POWER SUPPLY

PP3495A/UG

INTERIM CHANGE T- 1 TO NAVSHIPS 0967-425-1010 (94972), Technical Manual, dated 30 August 1963 for Power Supply, PP-3495A/UG.

Subj: Correction to Technical Manual for PP-3495A Power Supply NAVSHIPS 0280-824-4700 formerly NAVSHIPS 94972

Figure 1. Correction to Figure 2-2, Terminal Board Connection 48-Volt Output

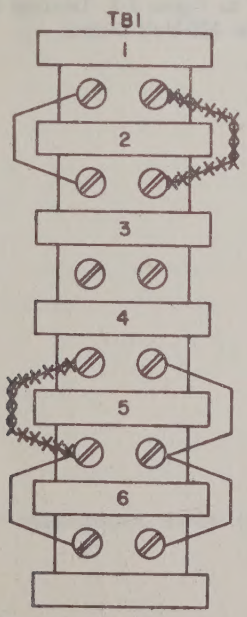
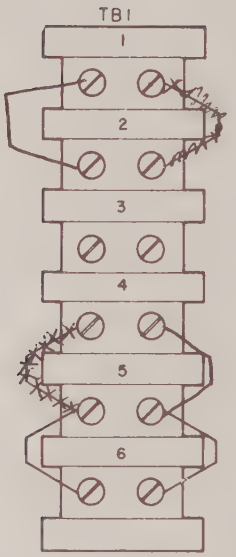
1. Page 2-1, figures 2-2 and 2-3, correct as shown in following figures.

Figure 6-3. Power Supply, Wiring Diagram, Connected for 48-Volt Operation

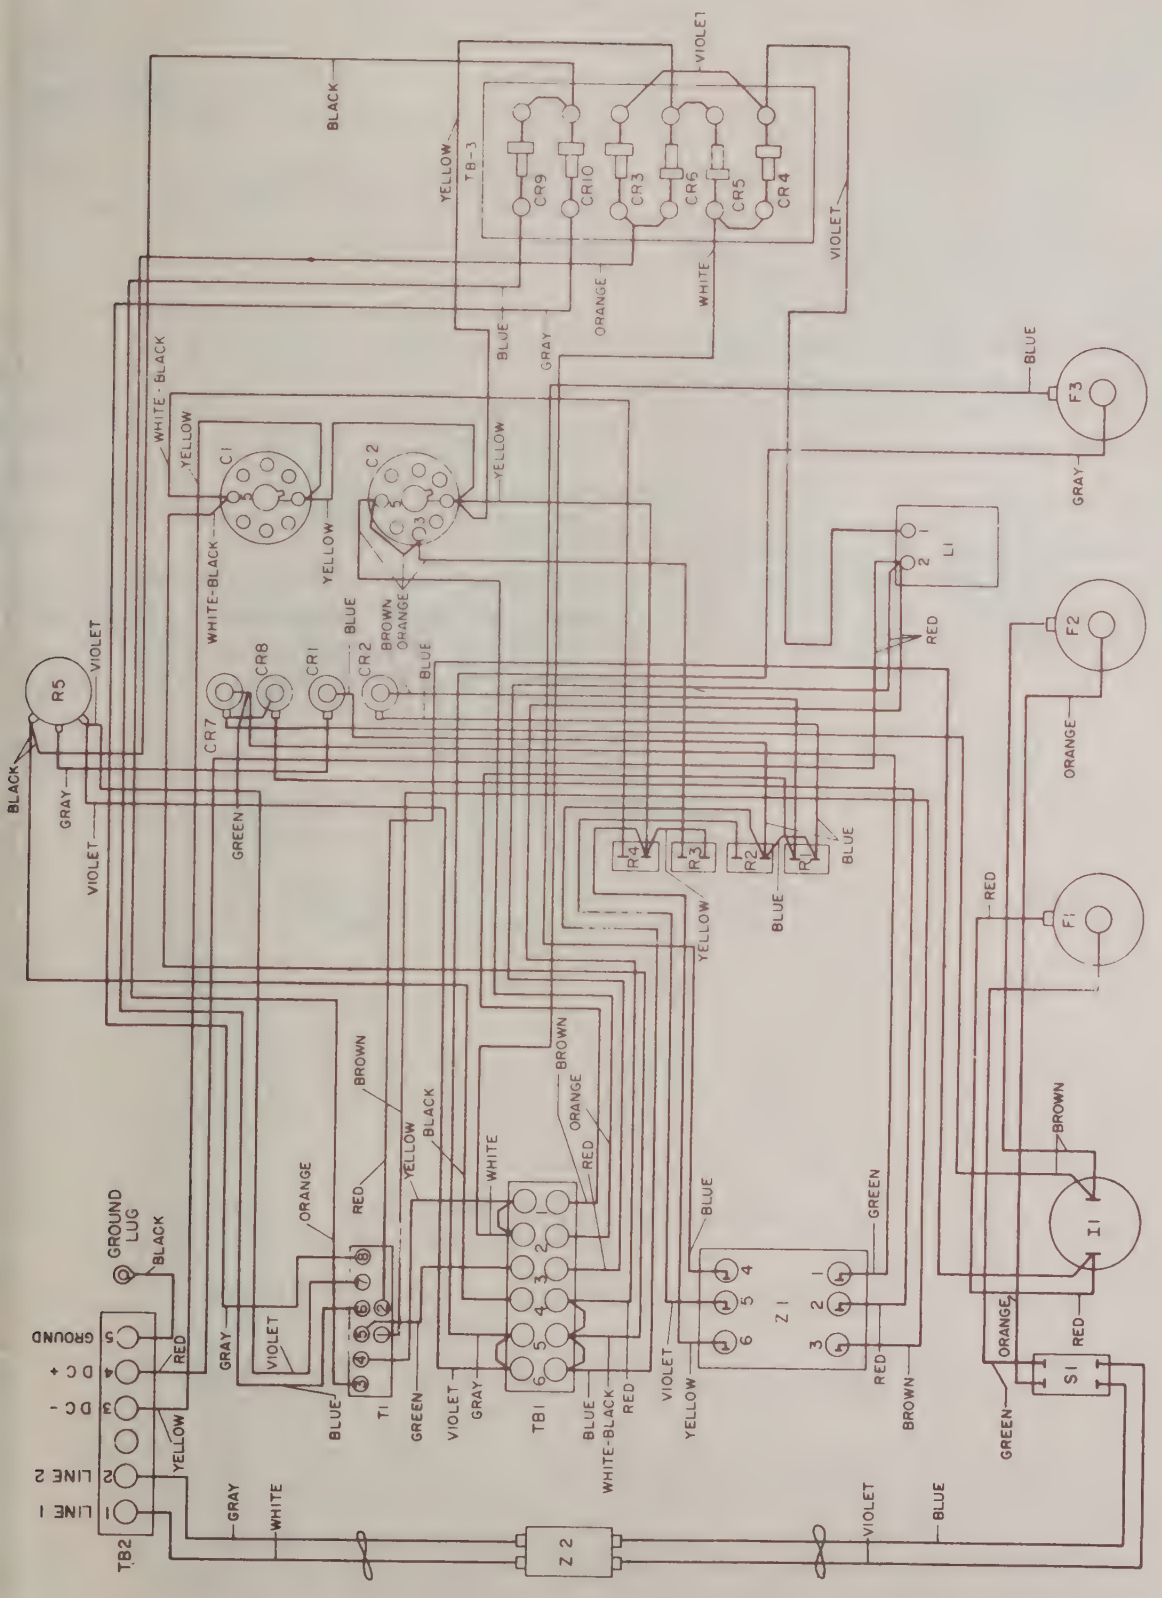
6. When replacing magnetic amplifiers assure that wiring is in accordance with Figure 6-3, page 6-4 of reference (c).
